**ADDENDUM TO IFB**

IFB Number: (IFB 17-008/JW)  
IFB Title: Cheek Phase V- Cheek Community Sewer Improvements  
(Grinder Pump and Force Main Installation) (TxCDBG No.7216231)  
IFB Due: **11:00 am CDT, Tuesday, October 24, 2017**  
Addendum No.: 2  
Issued (Date): October 17, 2017

### Cheek Community Sewer Improvements - Cheek Phase V Grinder Pump Installation & Force Main

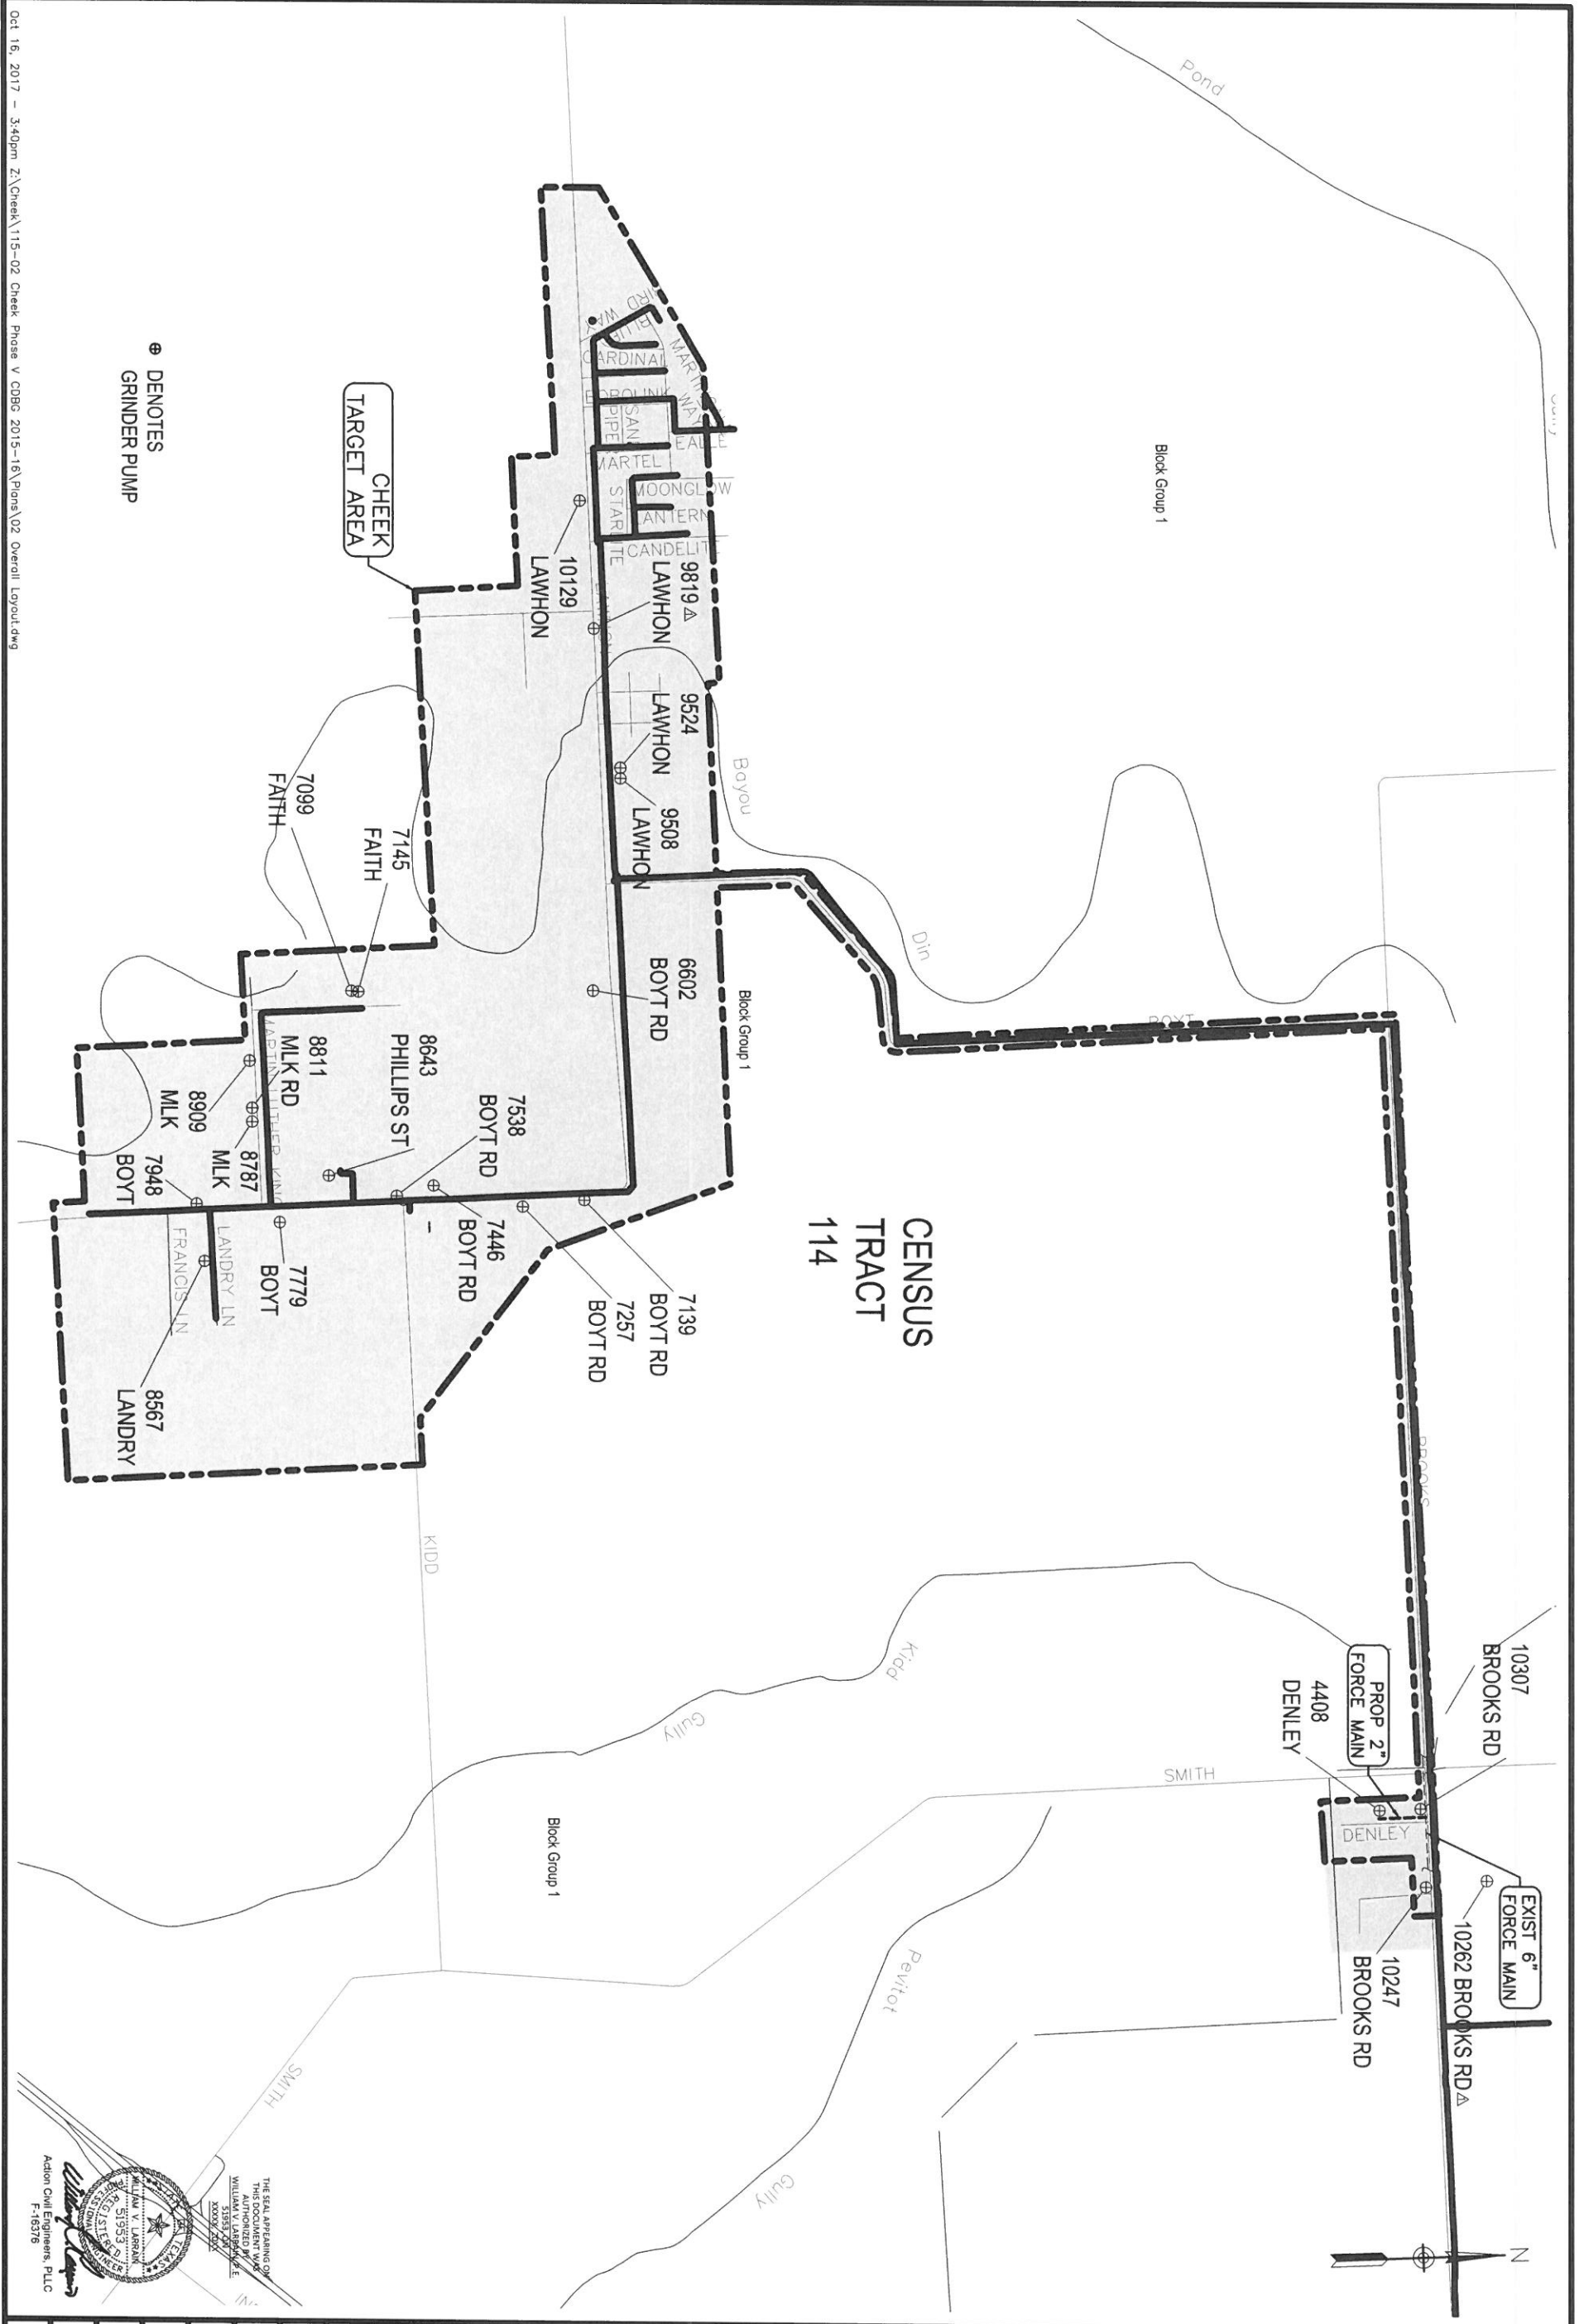
Please replace Page 2 of 6 of the Plan Sheets with the revised page included in this addendum. This page reflects the revisions to installation locations (addresses) included in the bid. This page replaces any previous version of the specifications.

10129 Lawhon	9819 Lawhon	9524 Lawhon
10262 Brooks Road	8643 Phillips Street	7139 Boyt Road
7257 Boyt Road	7446 Boyt Road	7538 Boyt Road
7779 Boyt Road	7948 Boyt Road	8909 MLK
10247 Brooks Road	4408 Denley	7099 Faith

10307 Brooks Road	9508 Lawhon	8787 MLK
8811 MLK	8567 Landry	
7145 Faith	6602 Boyt Road
